These amendments revise the TS requirements concerning heatup, cooldown and inservice testing limitations for the reactor coolant system.

Replace the following pages of the Appendix "A" Technical Specifications with the attached pages. The revised pages are identified by amendment numbers and contain vertical lines indicating the area of change.

SAFETY EVALUATION BY THE OFFICE OF NUCLEAR REACTOR REGULATION
SUPPORTING AMENDMENT NO. 107 TO FACILITY OPERATING LICENSE NO. DPR-38

OCONEE NUCLEAR STATION, UNITS NOS. 1, 2 AND 3

Figure 3.1.2-1C

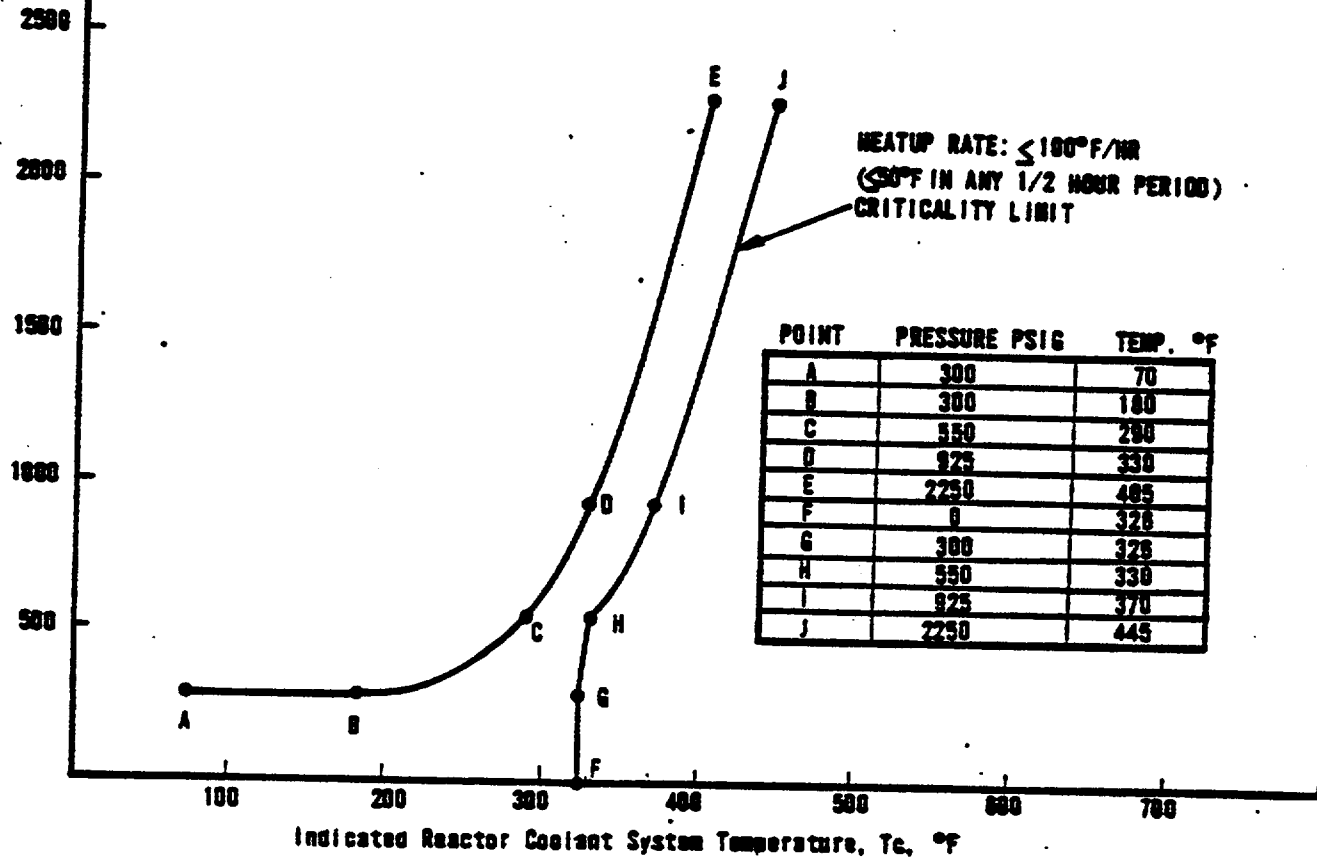
OCONEE UNIT 3 REACTOR COOLANT
 SYSTEM NORMAL OPERATION HEATUP
 LIMITATIONS APPLICABLE FOR
 FIRST 15.0 EFY.

THE ACCEPTABLE PRESSURE TEMPERATURE COMBINATIONS ARE BELOW AND TO THE RIGHT OF THE LIMIT CURVE(S). THE LIMIT CURVES INCLUDE THE PRESSURE DIFFERENTIAL BETWEEN THE POINT OF SYSTEM PRESSURE MEASUREMENT AND THE PRESSURE ON THE REACTOR VESSEL REGION CONTROLLING THE LIMIT CURVE. THEY INCLUDE AN ADDITIONAL MARGIN OF SAFETY FOR POSSIBLE INSTRUMENT ERROR (25 PSI AND 18°F). THE REACTOR MUST NOT BE MADE CRITICAL UNTIL THE PRESSURE-TEMPERATURE COMBINATIONS ARE TO THE RIGHT OF THE CRITICALITY LIMIT.

OCONEE NUCLEAR STATION
Figure 3.1.2-2A

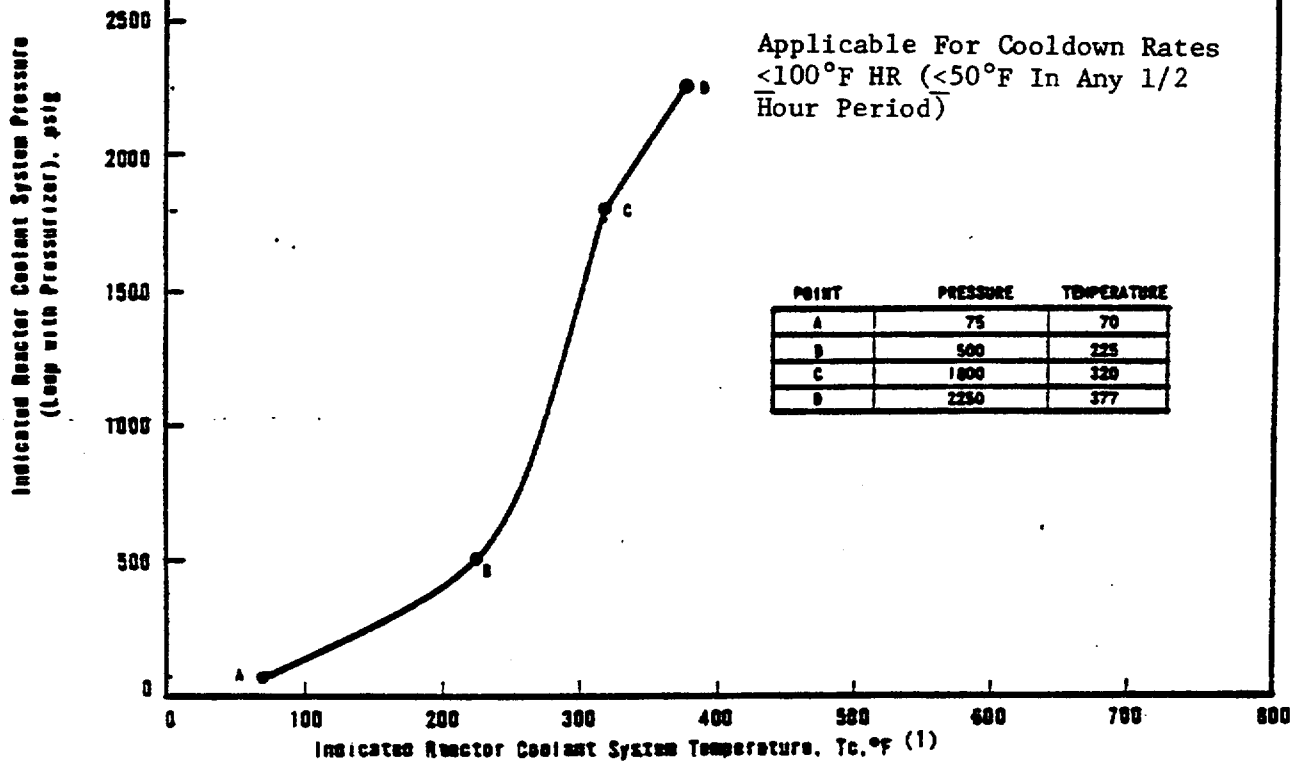
OCONEE UNIT 1 REACTOR COOLANT
SYSTEM NORMAL OPERATION COOLDOWN
LIMITATIONS APPLICABLE FOR FIRST
15.0 EFY

1. WHEN THE DECAY HEAT REMOVAL (DHR) SYSTEM IS OPERATING WITH NO RC PUMPS OPERATING, THE INDICATED DHR SYSTEM RETURN TEMPERATURE TO THE REACTOR VESSEL SHALL BE USED.
2. A MAXIMUM STEP TEMPERATURE CHANGE OF 75°F IS ALLOWABLE WHEN REMOVING ALL RC PUMPS FROM OPERATION WITH THE DHR SYSTEM OPERATING. THE STEP TEMPERATURE CHANGE IS DEFINED AS THE RC TEMP (PRIOR TO STOPPING ALL RC PUMPS) MINUS THE DHR RETURN TEMP (AFTER STOPPING ALL RC PUMPS) THE 100°F/HR RAMP DECREASE IS ALLOWABLE BOTH BEFORE AND AFTER THE STEP TEMP CHANGE.

OCONEE NUCLEAR STATION
Figure 3.1.2-3A

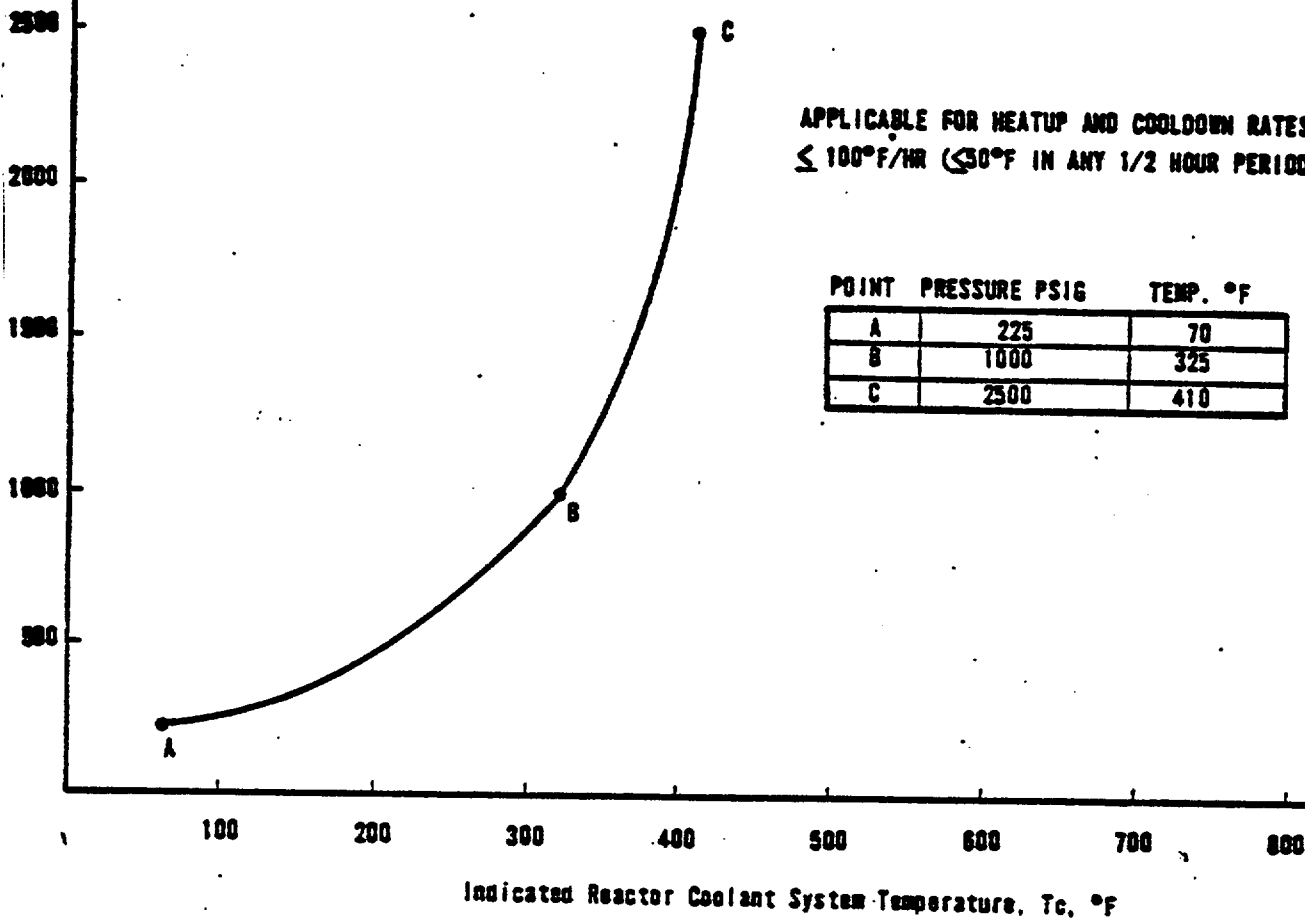
OCONEE UNIT 1 REACTOR COOLANT SYSTEM
INSERVICE LEAK AND HYDROSTATIC TEST
HEATUP AND COOLDOWN LIMITATION
APPLICABLE FOR FIRST 15.0 EFFECTIVE
FULL POWER YEARS

THE ACCEPTABLE PRESSURE AND TEMPERATURE COMBINATIONS ARE BELOW AND TO THE RIGHT OF THE LIMIT CURVE. MARGINS OF 25 PSIG AND 10°F ARE INCLUDED FOR POSSIBLE INSTRUMENT ERROR. FOR COOLDOWN, NOTES 1 AND 2 ON FIGURE 3.1.2-2A ARE APPLICABLE.

OCONEE NUCLEAR STATION
Figure 3.1.2-3C

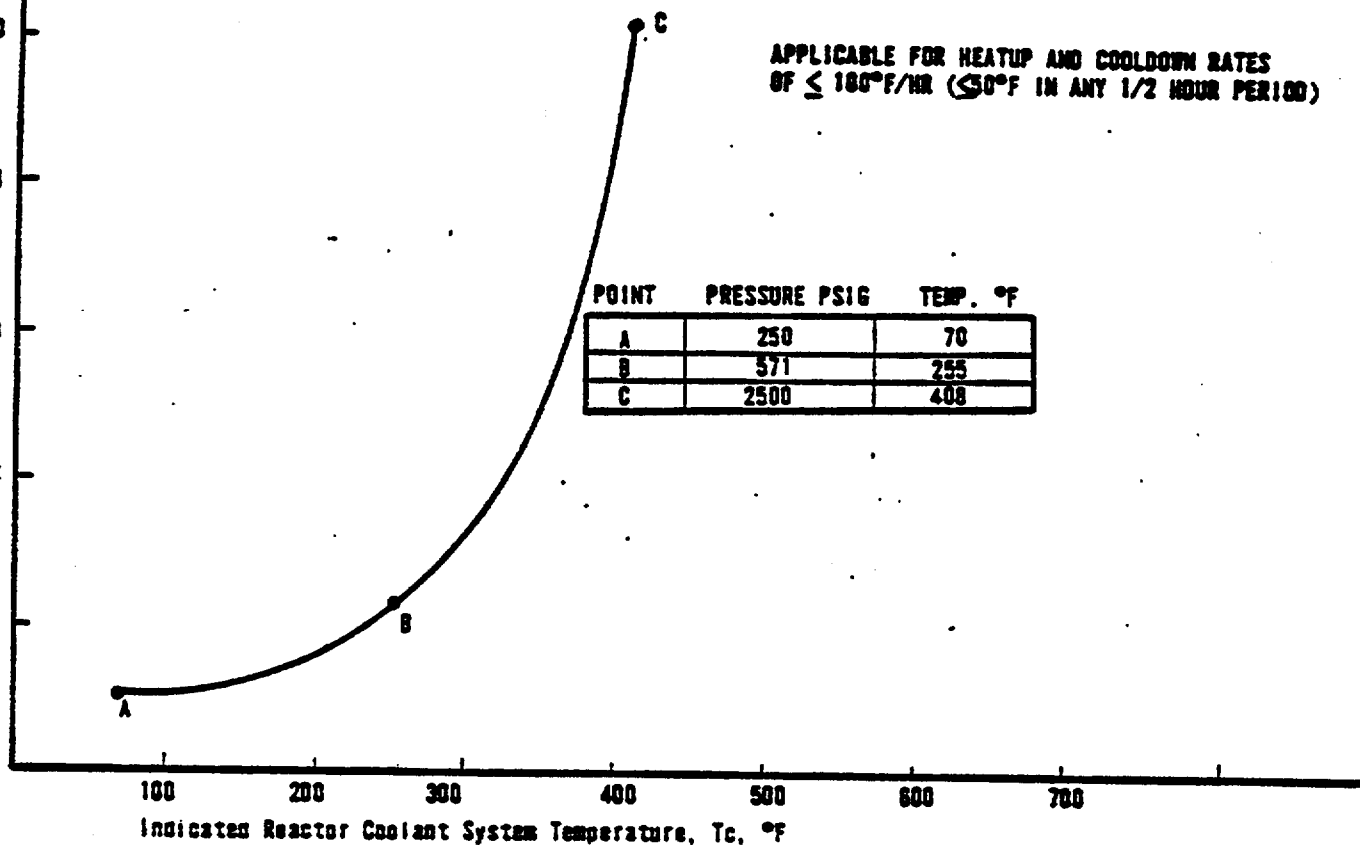
OCONEE UNIT 3 REACTOR COOLANT
SYSTEM INSERVICE LEAK AND
HYDROSTATIC TEST HEATUP AND
COOLDOWN LIMITATIONS APPLICABLE
FOR FIRST 15.0 EFPY

THE ACCEPTABLE PRESSURE-TEMPERATURE COMBINATIONS ARE BELOW AND TO THE RIGHT OF THE LIMIT CURVE(S). THE LIMIT CURVES INCLUDE THE PRESSURE DIFFERENTIAL BETWEEN THE POINT OF SYSTEM PRESSURE MEASUREMENT AND THE PRESSURE ON THE REACTOR VESSEL REGION CONTROLLING THE LIMIT CURVE. THEY INCLUDE AN ADDITIONAL MARGIN OF SAFETY FOR POSSIBLE INSTRUMENT ERROR, (25 PSI AND 18°F). FOR COOLDOWN NOTES 1 AND 2 ON FIG. 3.1.2-2C ARE APPLICABLE.

APPLICABLE FOR HEATUP AND COOLDOWN RATES
OF $\leq 180^\circ\text{F}/\text{HR}$ ($\leq 50^\circ\text{F}$ IN ANY 1/2 HOUR PERIOD)

POINT	PRESSURE PSIG	TEMP. °F
A	250	70
B	571	255
C	2500	408
